KINGSTON STEAM PLANT - ANNUAL ASH DISPOSAL AREA INSPECTION

September 27, 1974

KINGSTON STEAM PLANT - ANNUAL ASH DISPOSAL AREA INSPECTION

1. DIKE "C" SHOWING SOUTH END
OF EROSION AREA REPAIRED
WITH ROCK FILL. (ARROW) NOTE
THE GOOD VEGETATION.

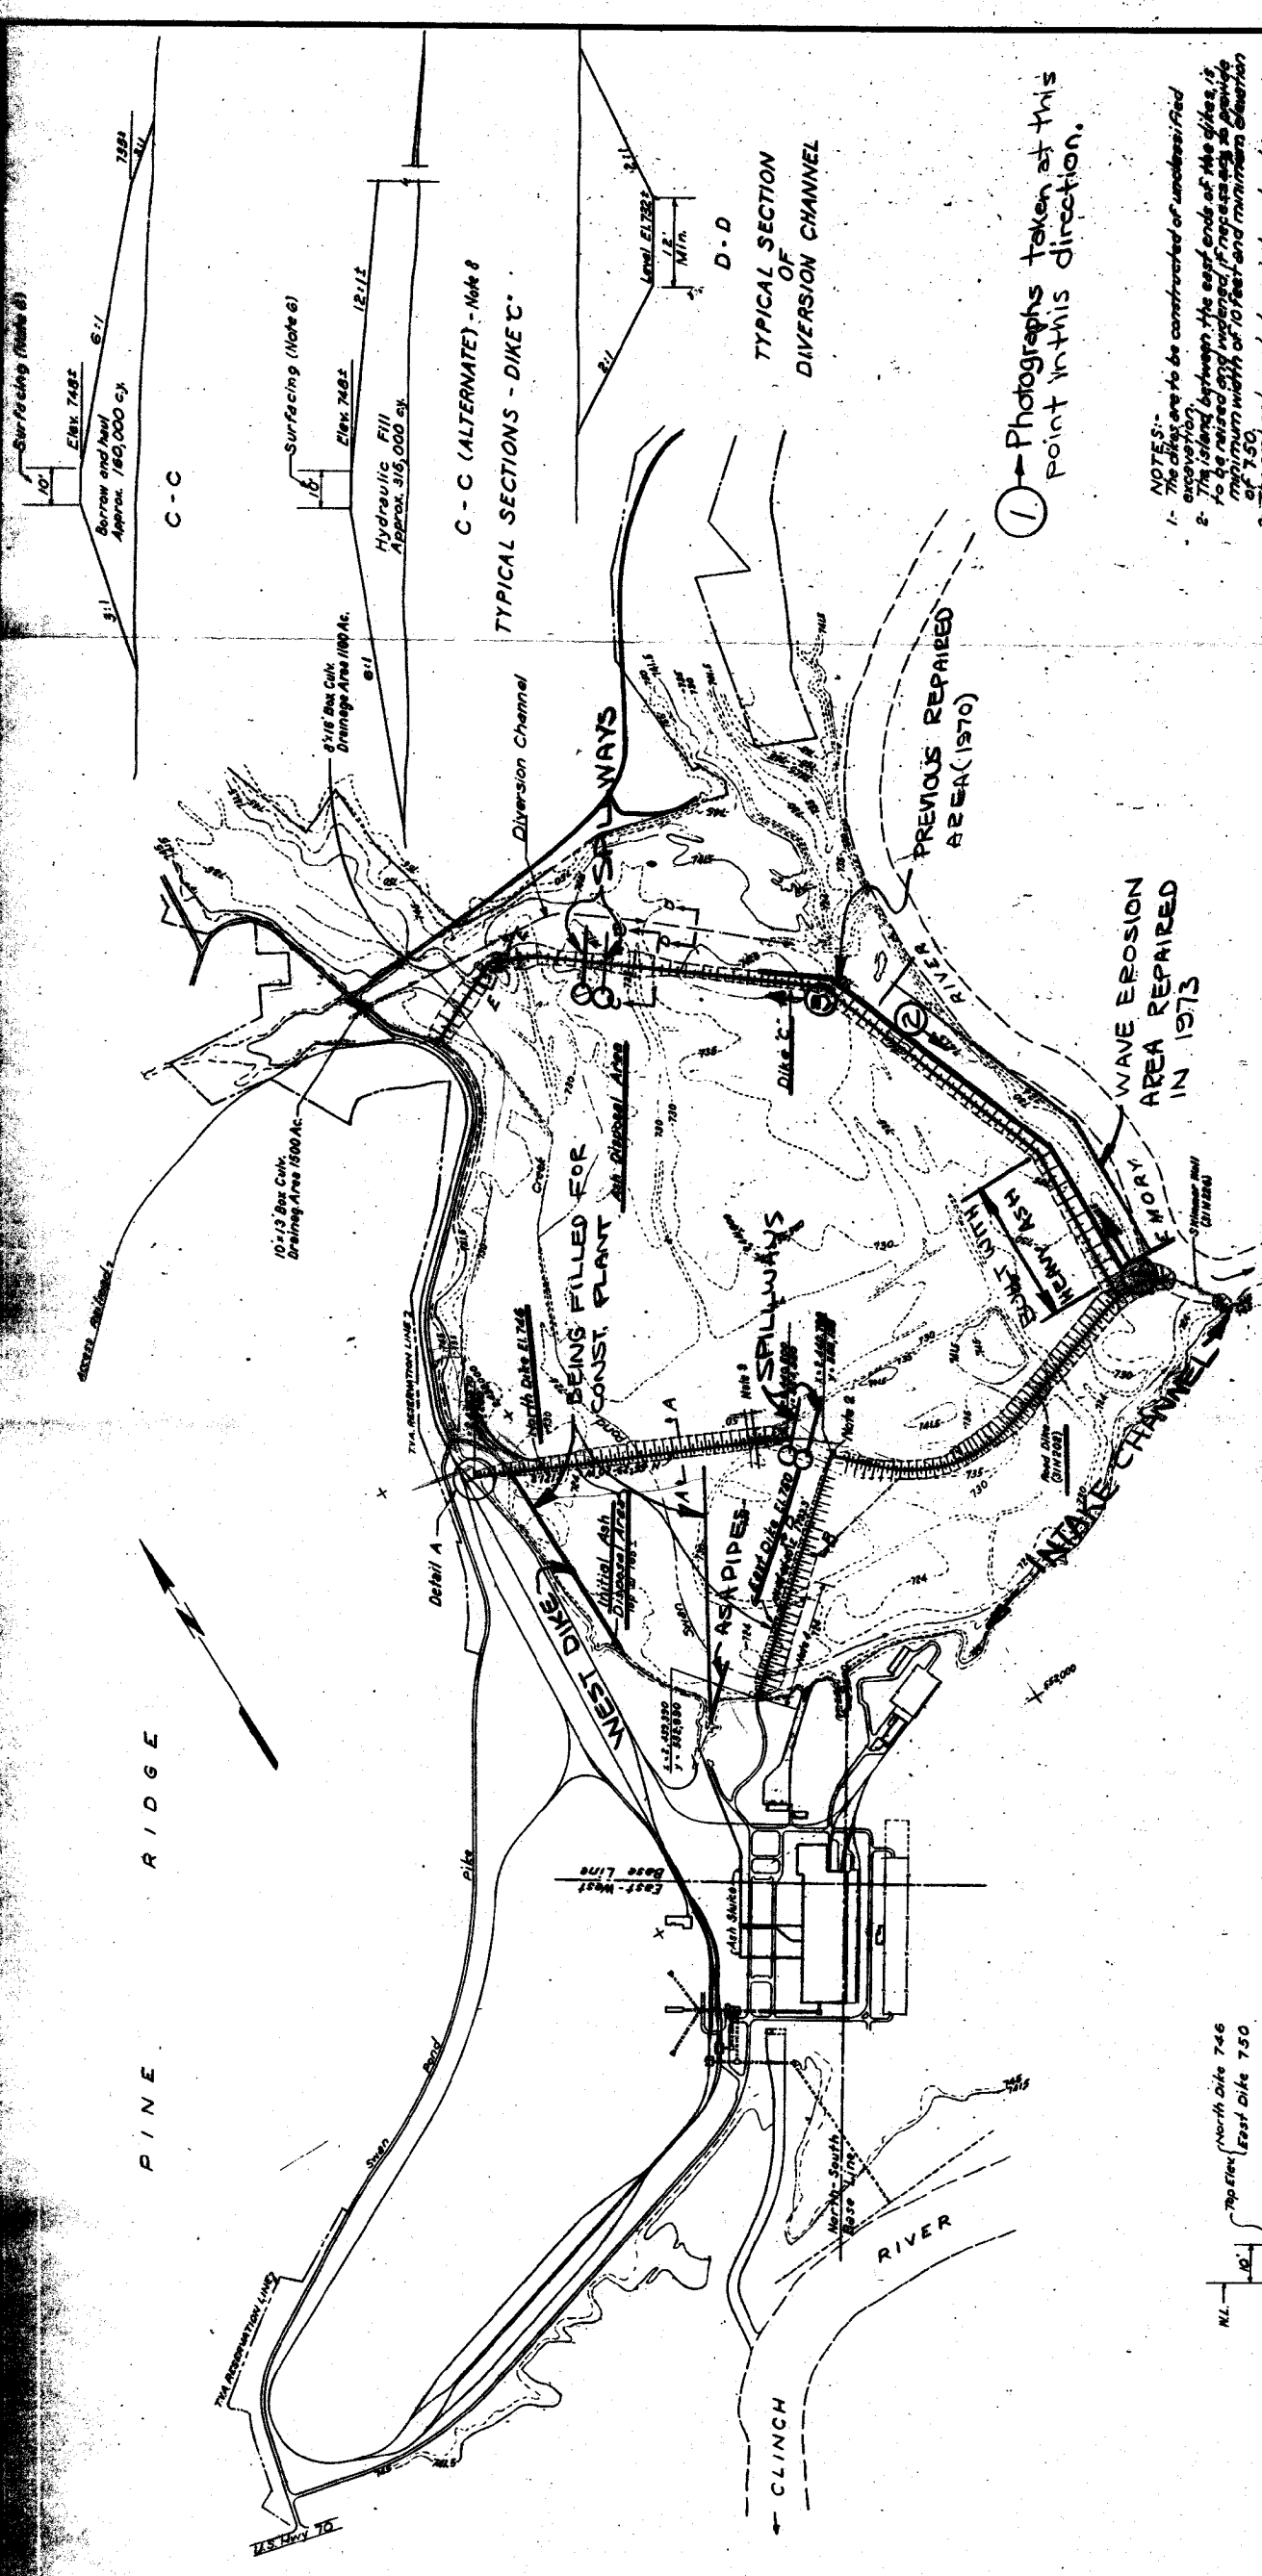
The area of erosion on the outside toe of dike C has been repaired with rockfill; and the slope above the rockfill that was disturbed during the repair operations has been smoothed, and an excellent cover of vegetation established (pictures 1 and 2).

1. The toe of the outside slope of dike C where the erosion had taken place has been rebuilt with rockfill as recommended. This should eliminate any further erosion in this area. The dike slope above the rockfill which was disturbed during repair of the toe has been graded smooth, covered with earth where needed, and seeded. An excellent cover of vegetation has been established on the slope including that part of the dike originally built with ash.
2. The trash has been removed from the outside slopes of all dikes.
